# **Springbank Off-stream Reservoir Project review**

## **Review of hydrogeology, groundwater modelling, water quality & geochemistry, and climate considerations**

The Springbank Concerned Landowners Group (SCLG)

The Natural Resources Conservation Board  
Application No. 1701

**Figure 10.** Reconstruction of past climate and flow conditions based on tree rings<sup>6</sup> with positive (blue) and negative (red) departures from mean conditions<sup>7</sup>

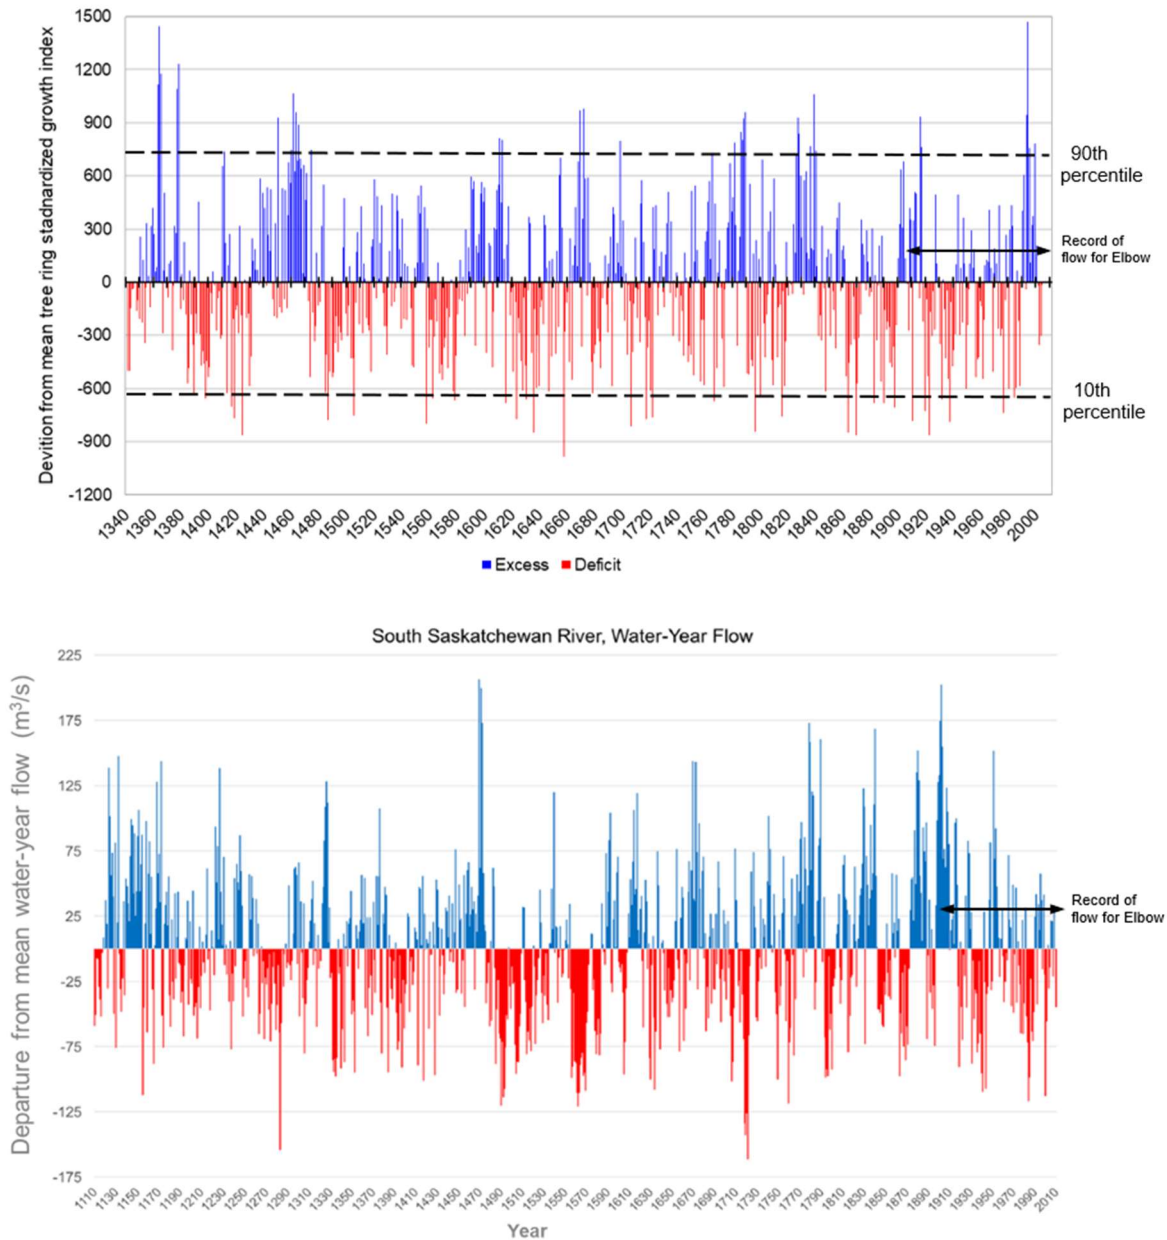
The upper image in Figure 10 shows results for a tree core taken from a Douglas Fir located in the Wildcat Hills area approximately 30 kilometers northwest of the SR1. Reconstruction of the past climate over the last 660 years or so indicates highly variable conditions, shifting from periods of excess (flood potential) to periods of deficit (drought potential). The black dashed lines on that upper image identify the 90<sup>th</sup> and 10<sup>th</sup> percentiles of the deviation from mean tree ring standardized growth index. These extremes are considered appropriate to describe potential flood and drought conditions, respectively. Of particular relevance is the number of times when the 90<sup>th</sup> percentile is exceeded and how these exceedances compare to the record of flow for the Elbow River.

The lower image in Figure 10 represents a reconstruction of streamflow for the South Saskatchewan River. Although this reconstruction includes both the Bow and Oldman watersheds, it does provide an indication of how streamflow conditions have changed in southern Alberta over the last 900 years. From a review of this figure It is apparent that there have been wet periods spanning several years to decades. When compared to the most recent flood events documented for Elbow River (Figure 11), it is would appear that the assessment of flood conditions has not captured the full range of conditions that could be expected.

There is also a complete lack of consideration for drought conditions, which have equally manifested themselves in the region over the past several hundreds of years (Figure 10). There has been no exploration of how extended drought conditions affect the viability of the SR1 management system. One consideration to keep in mind is the risk of wind-blown dust from accumulated sediments in the SR1 reservoir. There are likely others; however, this has not formed part of the applicant's assessment process and is therefore a notable gap. Although this is currently not the intended use of the SR1 reservoir, but if the decision were ever made to use the structure as a longer-term storage of water for City of Calgary drought mitigation, the feasibility of such a use would have to be assessed given the physical and geochemical concerns raised in this submission.

**Figure 11.** Observed and Estimated Peak Instantaneous Flows of Elbow River at Bragg Creek Station (1908-2013)<sup>8</sup>

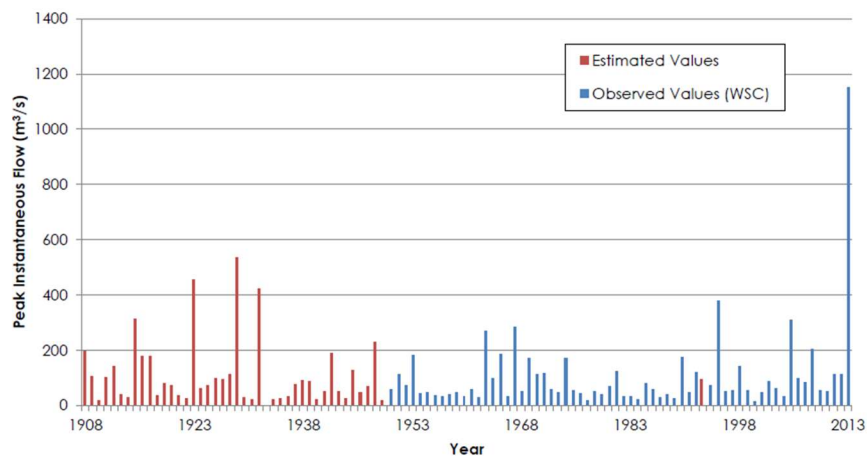
This type of reconstructive analysis provides a view into the past and an indication of what might happen in the future. Additionally, the global climate modelling community has produced a number of useful General Circulation Models (GCMs) to project future changes to temperature and precipitation conditions under varying greenhouse gas emissions and global warming scenarios. Based on the output of these GCMs, future precipitation in the Elbow River watershed is anticipated to increase up to 12% annually by the end of this century, and up to 34% during the Spring period<sup>9</sup>. The results of these projections are summarized in Figure 12. Timing of the freshet is also projected to shift to earlier in the year by approximately 1 month as the winter season shortens. A change in the magnitude and seasonality of precipitation and an increase in the magnitude of peak flows is also anticipated (Figure 13).

**Figure 16.** Difference in flood return periods and flow magnitudes when wet years area assessed separately from the entire period of record (using Log Pearson Type III method)<sup>17</sup>.

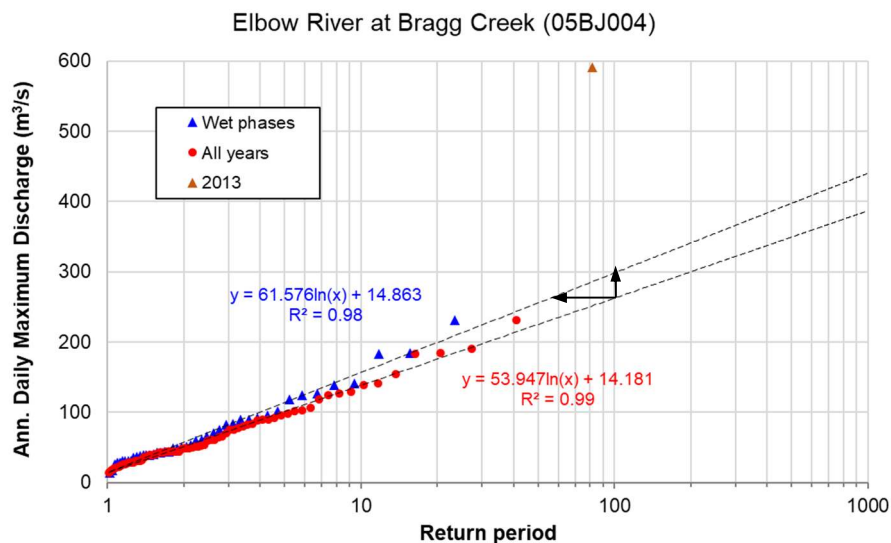
Although there have been various flood statistics communicated by the applicant in their submissions, and the results shown in Figure 15 may differ from those due to the used of differing data sets, they have been provided for illustrative purposes. It should be noted that the flood event of 2013 has not been included because of its outlying nature and influence on the associated regression line for the “Wet phases” data. Despite not including the 2013 flood event it is clear that during wetter climatic conditions the return periods for events like a 1:100 or 1:200 flood become more frequent (e.g. a 1:100 event shifts to a 1:60, or so, return period). Equally, the magnitude of flow associated with typical 1:100 event during wetter climatic periods also increases.
